## **NORTH PLANNING COMMITTEE**

### **SCHEDULE OF ADDITIONAL LETTERS**

**Date: 22<sup>nd</sup> March 2016**

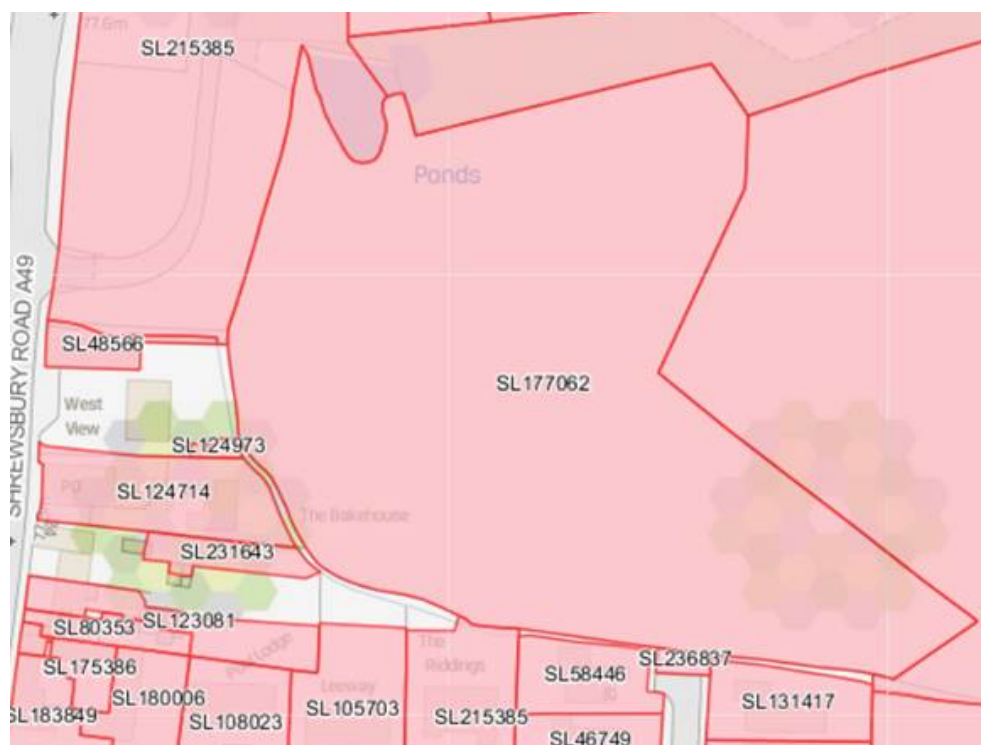
An objection letter has been received from the neighbour at White Lodge. The neighbours consider that the increase in the height of the dwelling(s) as now amended is unacceptable. It will increase the height by 800mm and this will impede their right to daylight/sunlight when the 25 degree BRE daylight test is applied. Also they comment that the ridge of the re-positioned house will be 1 m closer than previously. They request an amended street scene is provided to demonstrate the revisions will not adversely impact on their amenity.

Officers would also highlight the fact that the eaves and ridge height denoted on the previous drawing (Rev B) measured the eaves and ridge height from two brick courses above ground level. Therefore the actual increase in height would be less than 800mm, and in the region of 650mm.

In response, officers would comment that the matter of the increase in height is discussed in the report to committee in section 6.1 and summarised, including reference to light, at 6.1.9: *'On balance overall, officers are satisfied that the scheme as now amended, will not result in an unacceptable loss of privacy or light to main habitable room windows of neighbouring development, and overall the latest amended plans are considered an improvement in relationship to the site and the previous proposal deferred from the January Committee.'*

Officers are satisfied that the increase in height will not adversely impact on the neighbours in terms of loss of light and in this context would reiterate that the existing ground levels are to be reduced and furthermore
